Ref: 0541r02v01

**RE: 182—186 GERTRUDE STREET, NORTH GOSFORD
DEVELOPMENT APPLICATION FOR A RESIDENTIAL DEVELOPMENT (DA23/3021)
TRAFFIC LETTER OF RESPONSE TO COUNCIL REQUEST FOR INFORMATION**

Project 182 - 186 Gertrude Street, North Gosford	Drawing Title Swept Path Analysis Level 02 B99 Passing B85 Design Vehicle at Site Access	Drawing No. 001	Revision No. -
Project No 0541	Sheet Status NOT FOR CONSTRUCTION	Drawn By BM	Date 31/01/2024
Scale 1:200 @ A3

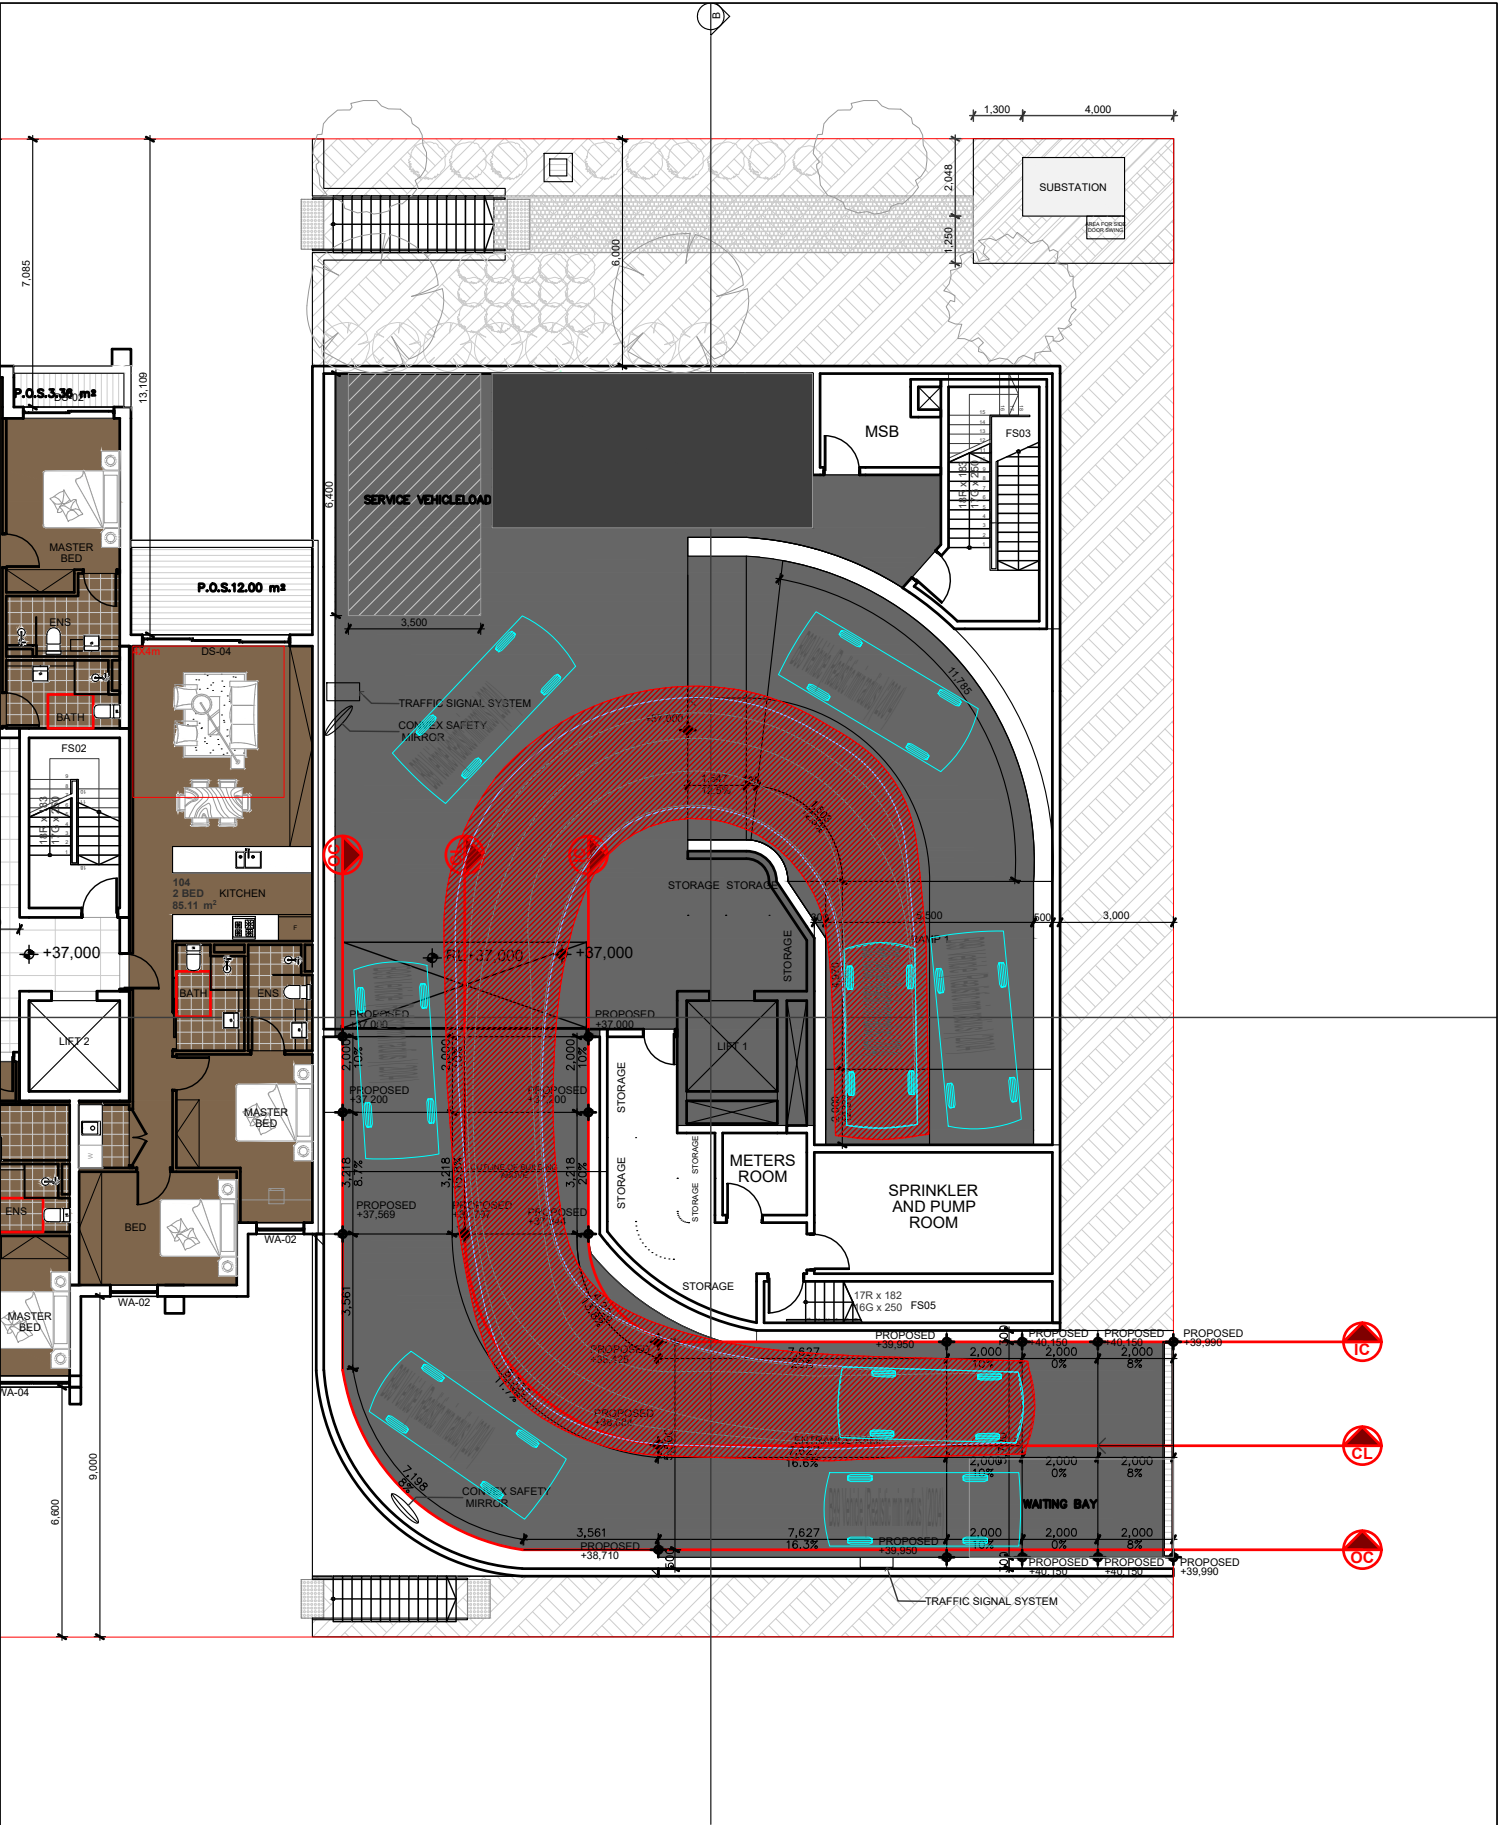
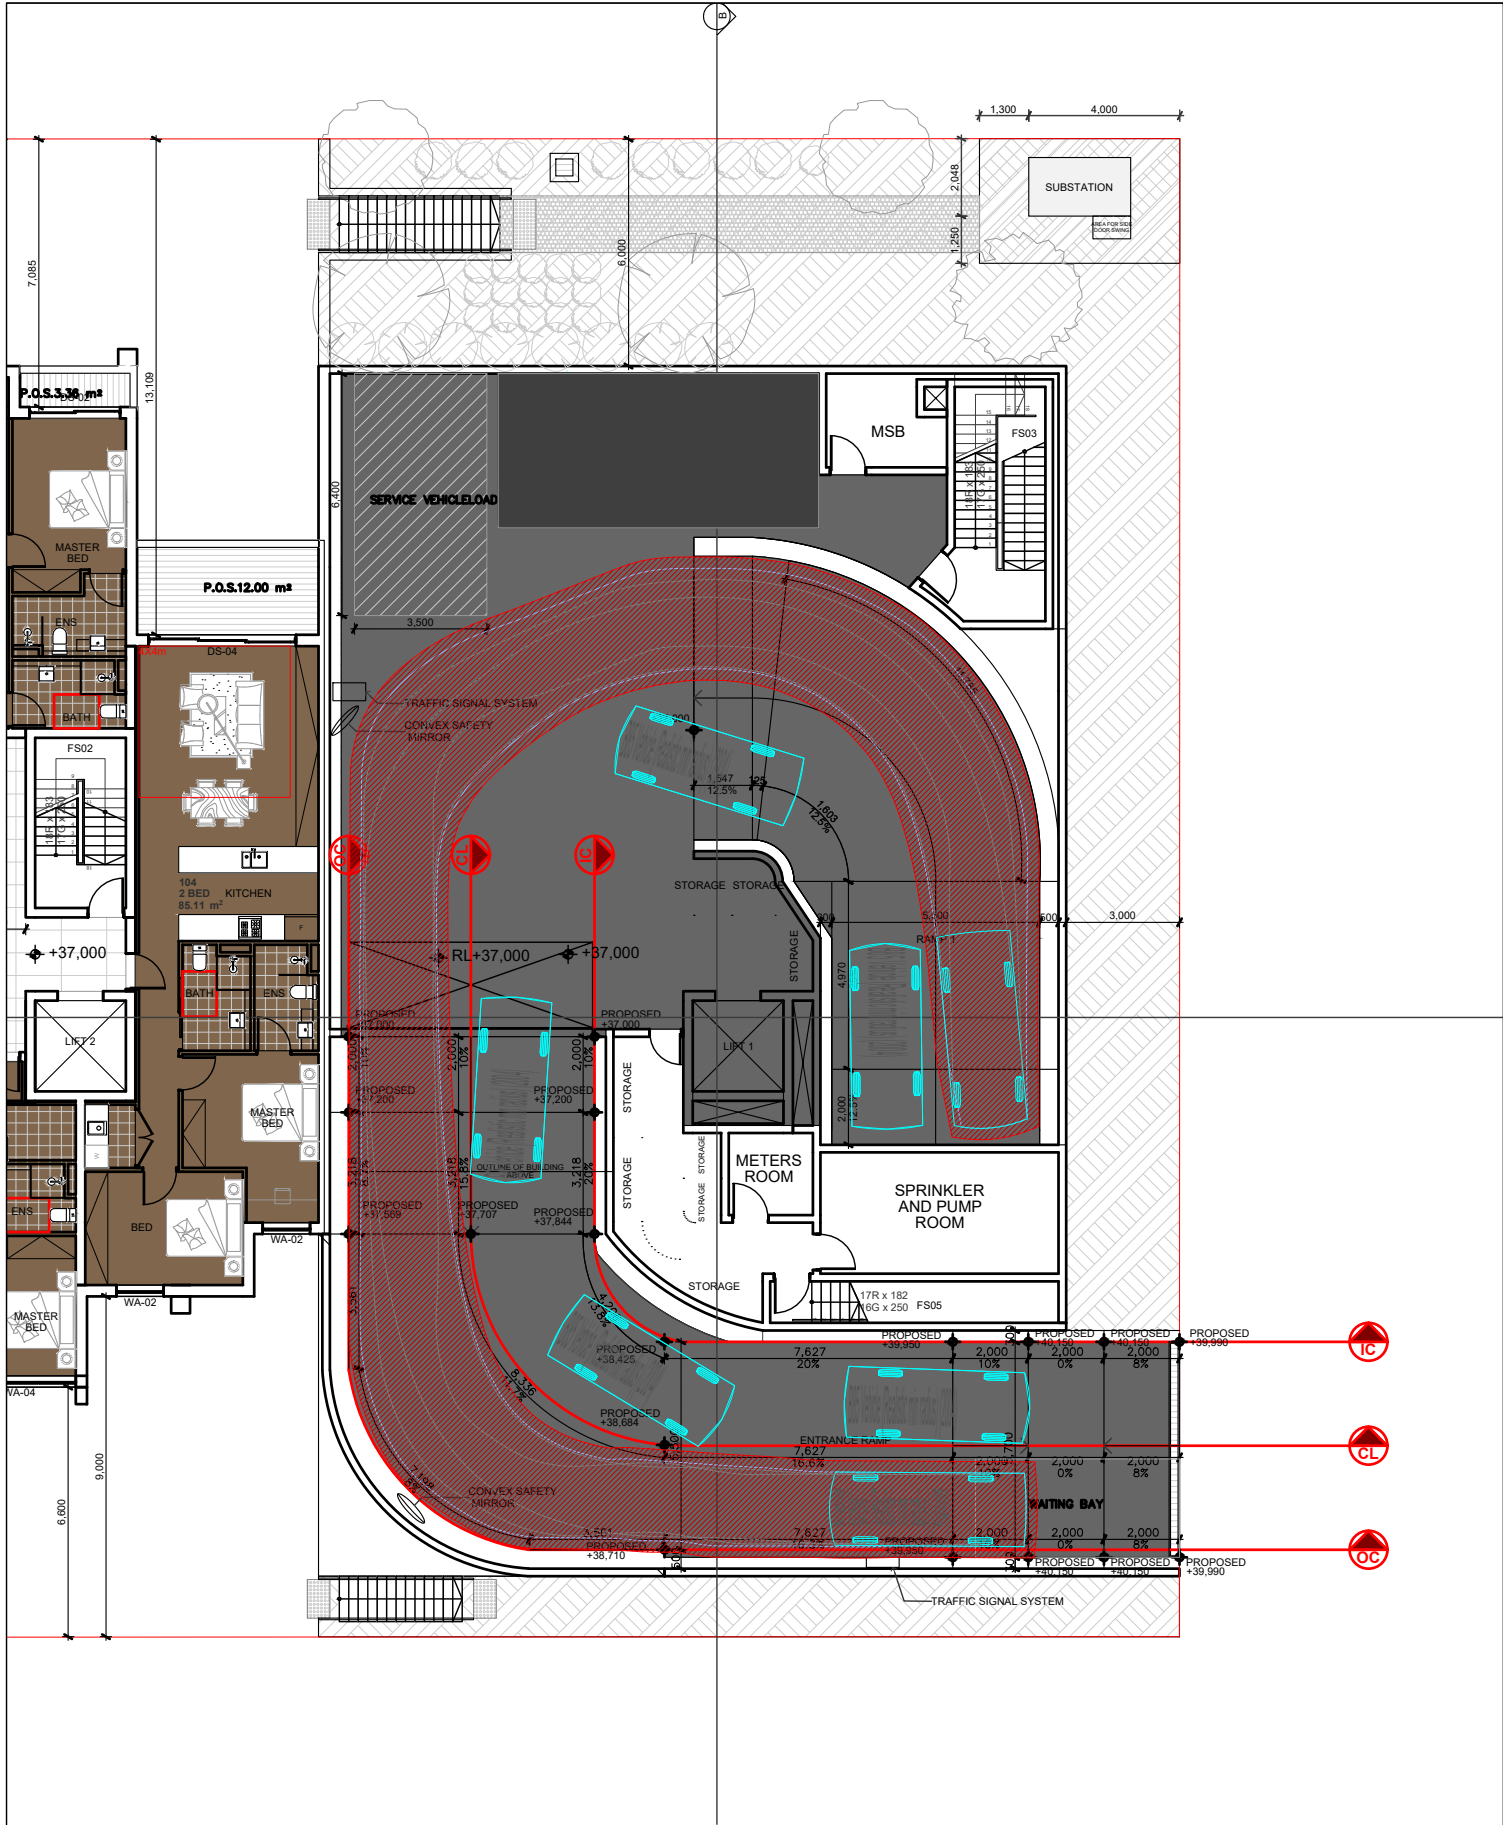
Requests to widen circulatory ramps to improve vehicle manoeuvrability

Satisfactory two-way passing along these ramps is demonstrated by amended swept paths provided as **Attachment 2**.

IC - INNER CURB SECTION

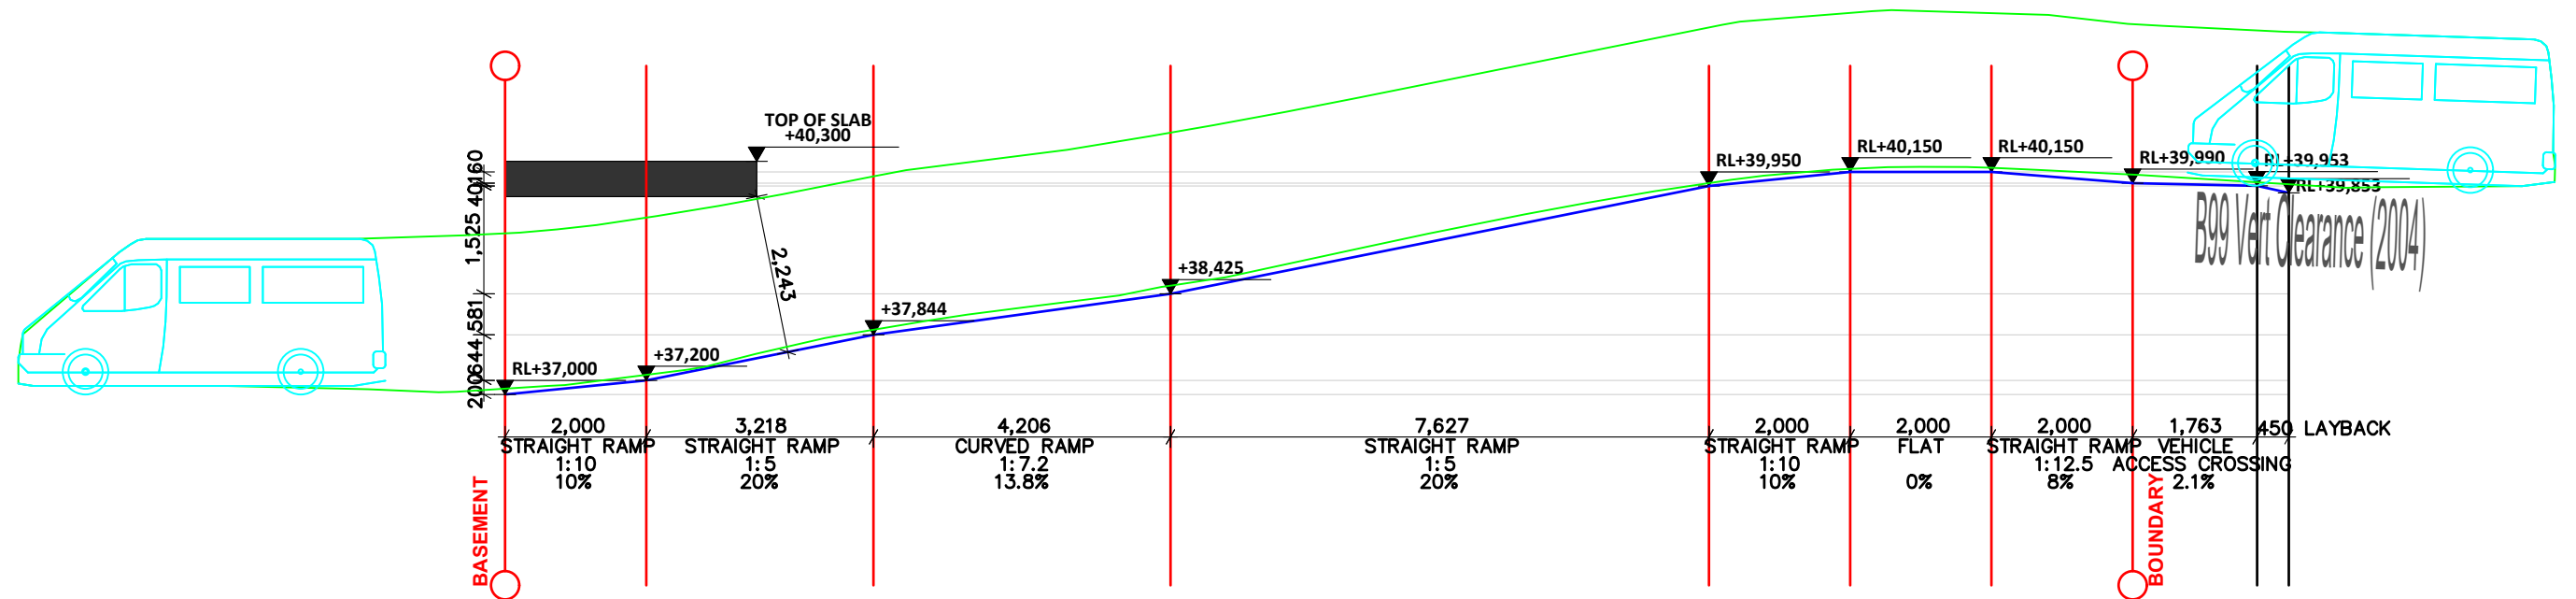
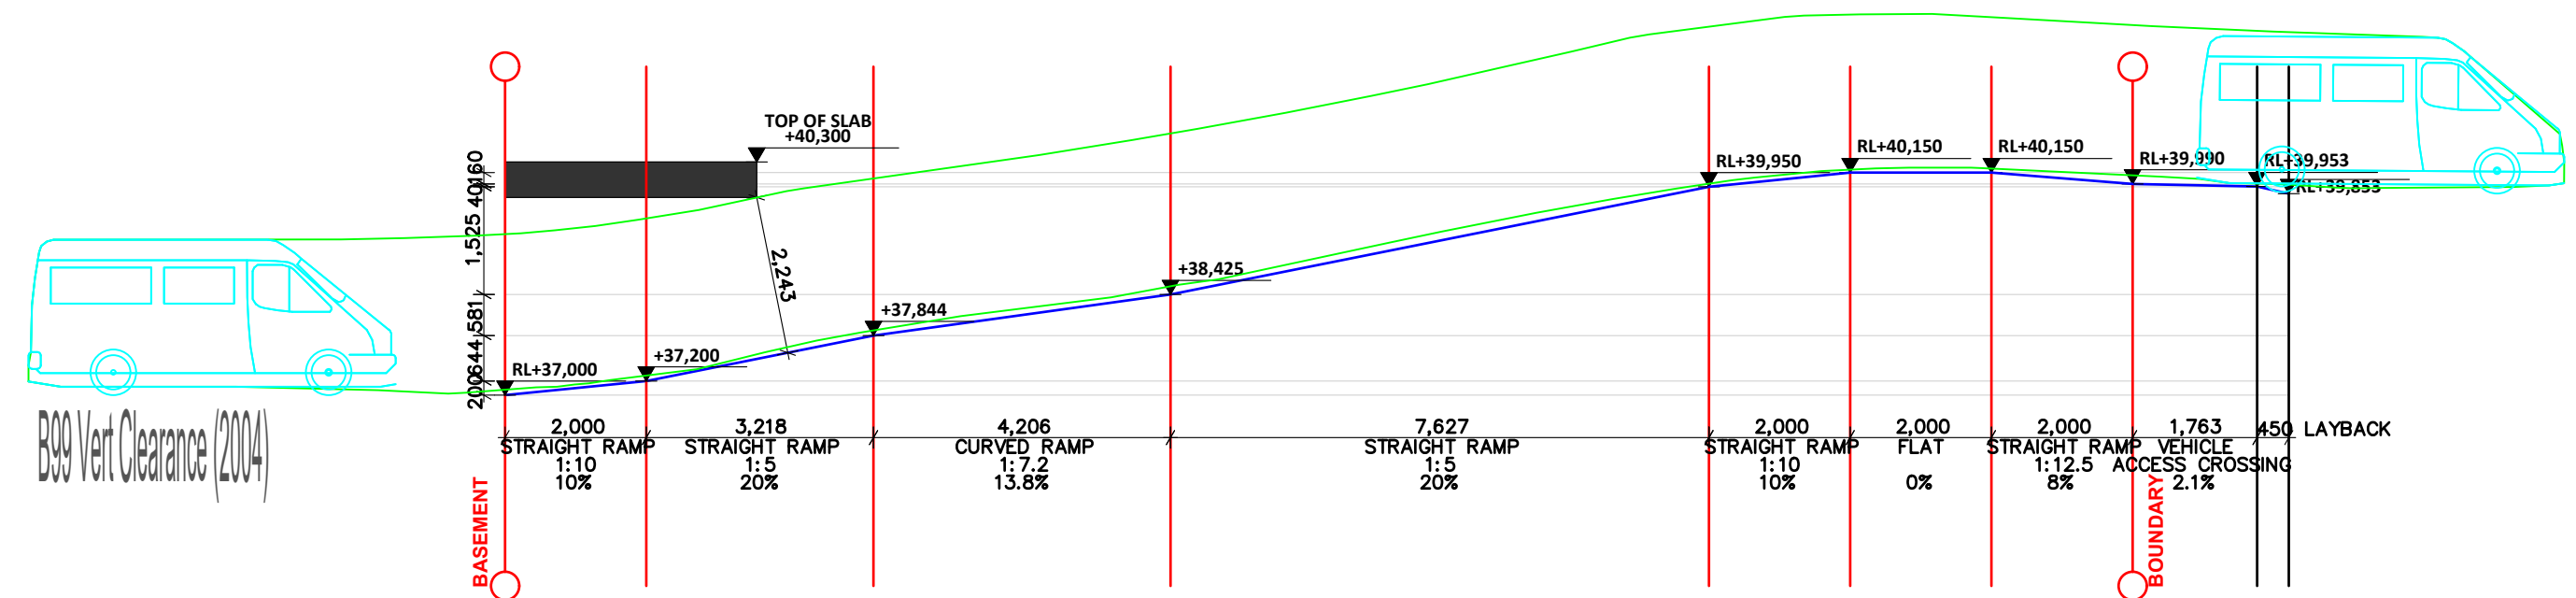
Lack of detail over the proposed vehicle ramp and long sections

Vertical clearance swept path analysis has been run along the inner kerb edge, being the critical long section, using a B99 design vehicle. This analysis, provided as **Attachment 2**, demonstrates satisfactory ground clearance for a vehicle entering and exiting the site via the ramp and as such, the proposed arrangements are considered satisfactory.
